**CALIFORNIA COASTAL COMMISSION**

**STAFF REPORT:**  
**PERMIT AMENDMENT**

**APPLICATION NO.:** A-1-MEN-01-043-A1

**APPLICANTS:** KEN AND JILL ROOST

Lot #11 Weikel and Lot #12 Abramson  
Fence between two parcels - goes way down  
between the two houses.

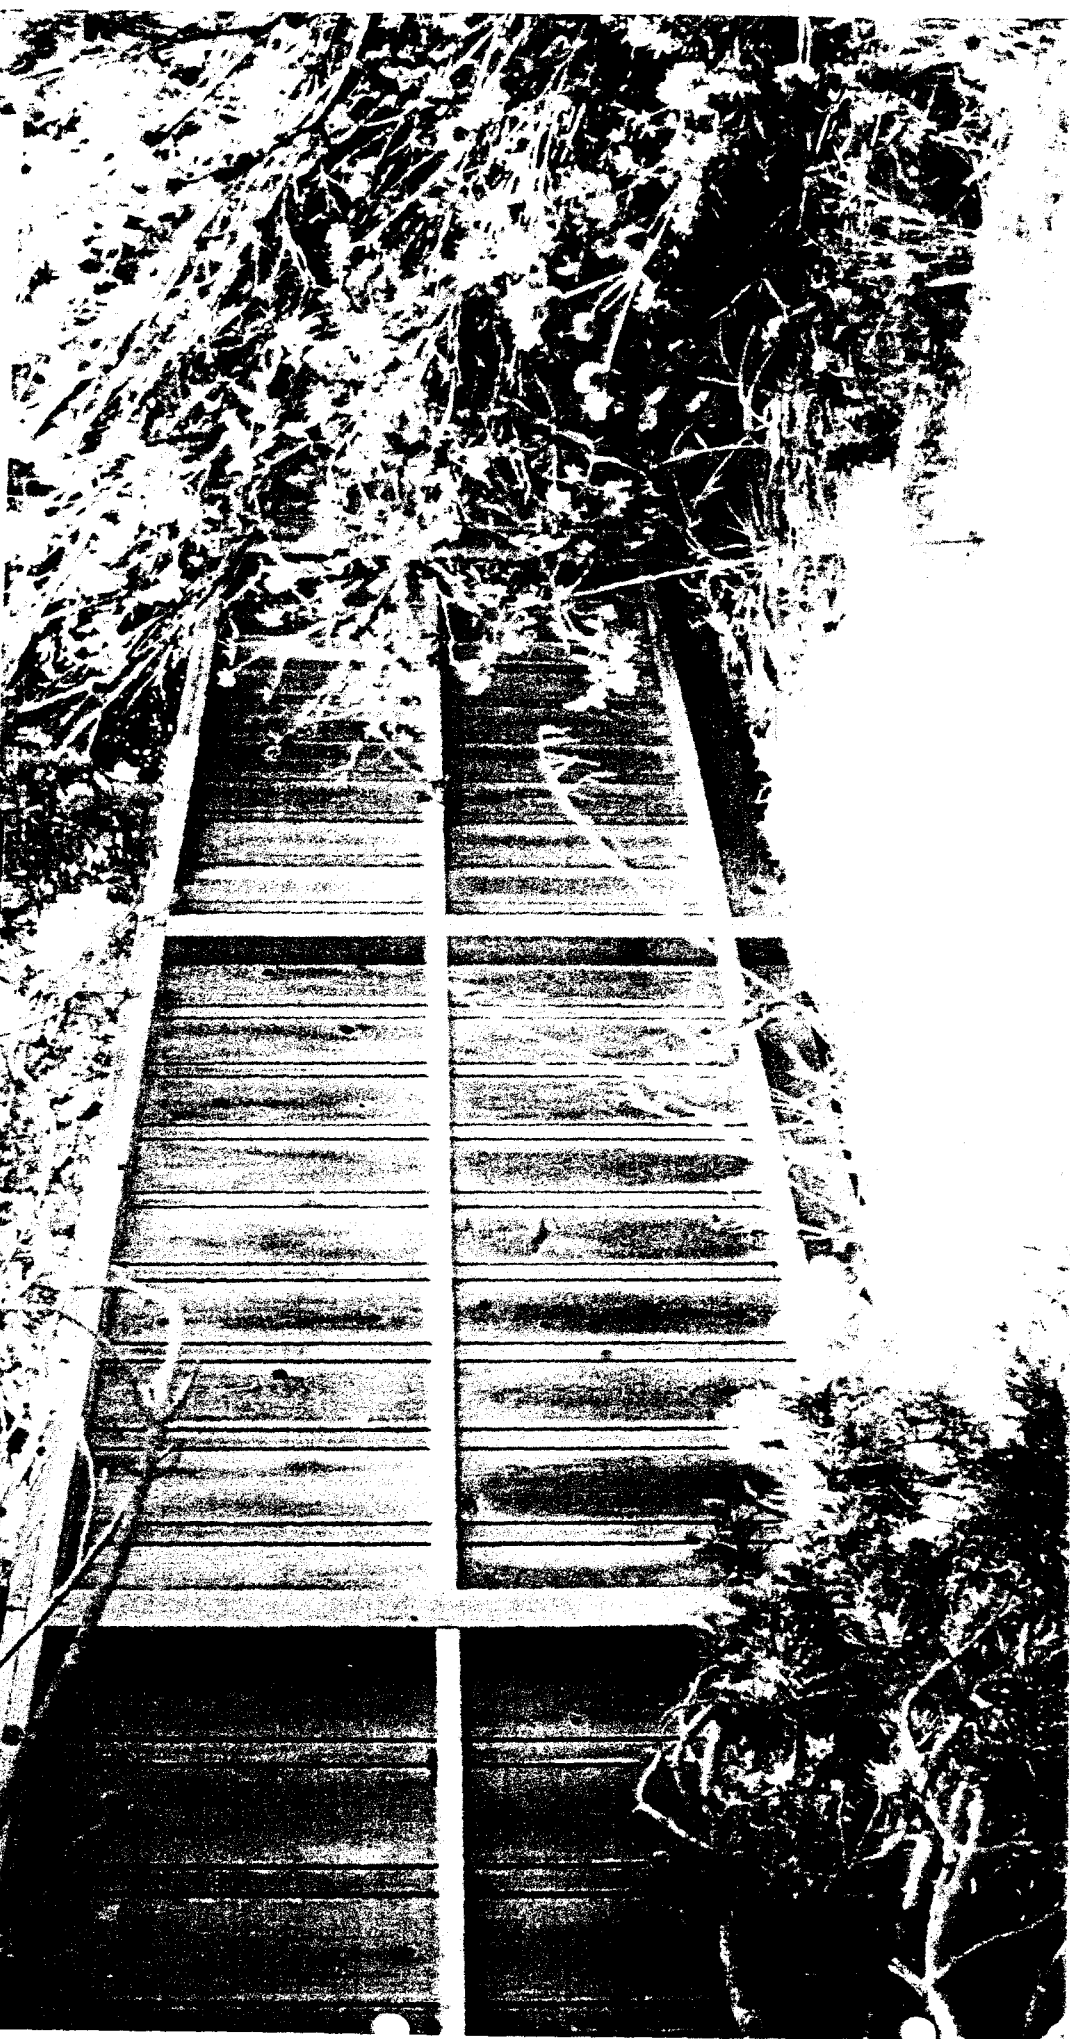
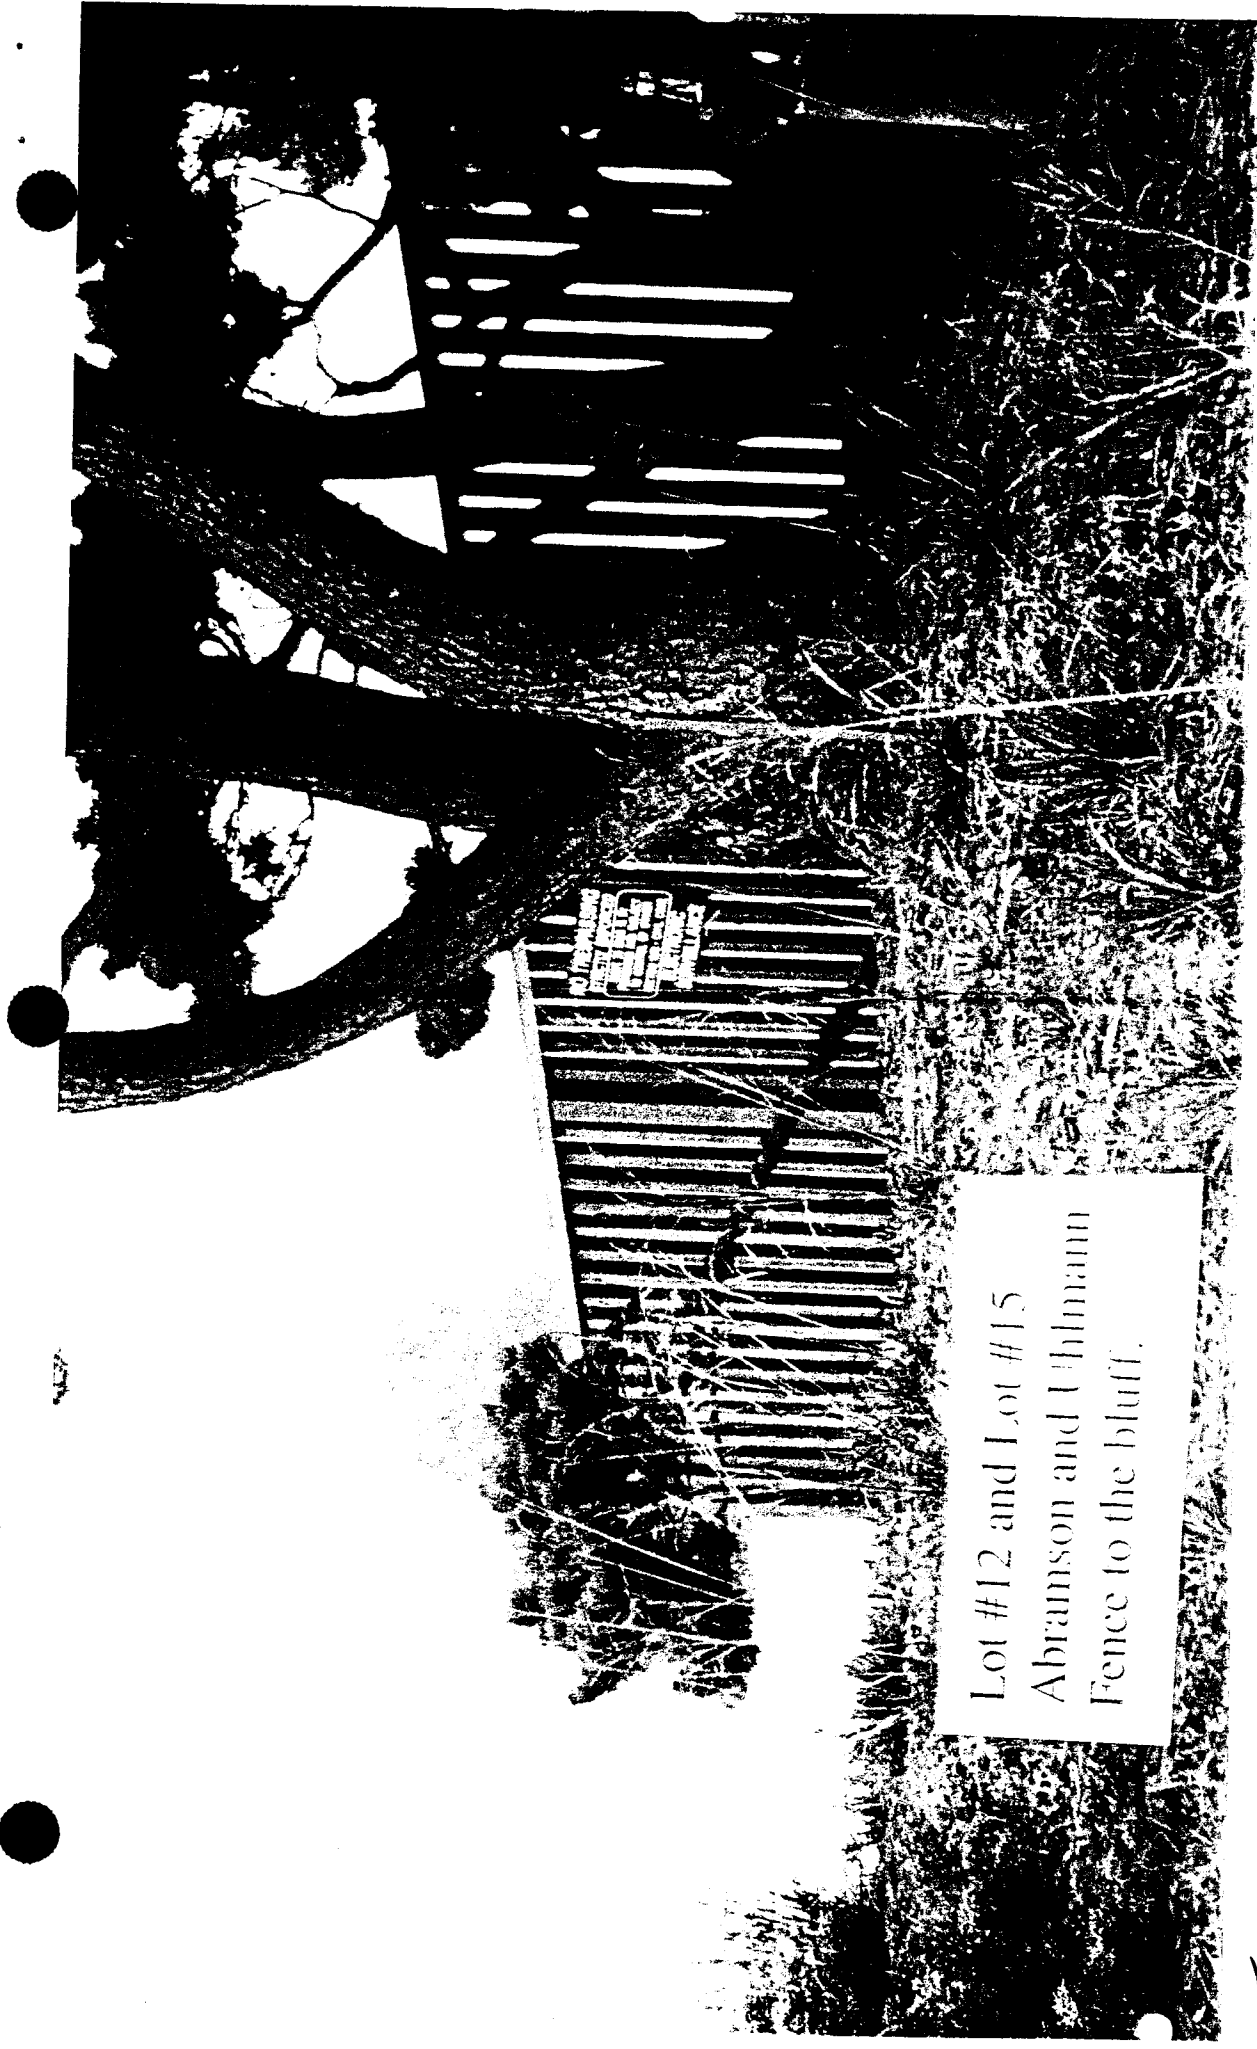
- As the proposed fencing would make a substantial contribution to the exterior appearance of the proposed residential improvements at the site, supplementary information is needed so that we may conclude that the fencing would be compatible with the similar surrounding development. Please provide an addendum to the compatibility study detailing the types, heights, and extent of fencing on other lots within the Little River Headlands Subdivision neighborhood. In addition please indicate what if any existing vegetation may exist in proximity to the proposed fencing and how that vegetation might screen or soften the appearance of the fence within those areas on the parcel visible from public vantage points (see Exhibit No. 11 of the November 22, 2002 revised findings staff report).

RESPONSE: Addendum to compatible study. I have enclosed a number of colored photographs enlarged to 11" X 17" that show the fencing within the Little River Headlands Subdivision. Almost all of the lots have single family residences. The Langer's are currently under construction of their SFR on parcel 2. Parcel 6 is owned by Glen Ricard and does not contain a residence but is fenced on all three sides. It has been used as a site for a horse. Lot #14; Uhlmann contains the septic system for Uhlmann's residence on Lot #15. The only Lot not built on in the subdivision is the Roost Lot #10. This past week I visited the subdivision and inventoried the fencing. As you know there is a metal sliding entrance gate that is approximately 20' across. Adjacent to the gate is a pass through pedestrian gate. These gates are approximately 6'-8' high. Around the entrance gate is approximately 380' of fencing. Of this 380 feet of fencing approximately 280' is solid 6' high grape stake fencing. The other 100 feet of fencing is approximately 4' high with 2"-3" spacing between the boards. There is no fencing around lots 1-4 that are on the north side of Headlands Drive. Lots 5, 6, and 7 are fenced on all three sides right to the bluff. Most of the fencing is 40" high. There is fencing on the east side of the Tower lot (8) and a small amount of fencing on the Burke parcel (9). There is fencing on the east side of the Weikel property (11) and on the east side of the Abramson parcel (12) This is solid fencing 6-7" high that runs approximately 40' in length. Lots 14 and 15 (Uhlmann) are fenced in the front. The fencing is approximately 3 1/2 feet high. The Calof parcel has a low fence along the street which is about 2' high. All the fencing is shown on the Map marked #3... The whole subdivision contains a substantial number of pine trees. The subject parcel lot #10 has 8 pine trees on the north side that are 15-40' in height. There are 13 trees on the east side that are from 5-15 feet in height and there are 6 trees on the west side adjacent the Weikel property line that are 20-50' in height... All the trees are pine.
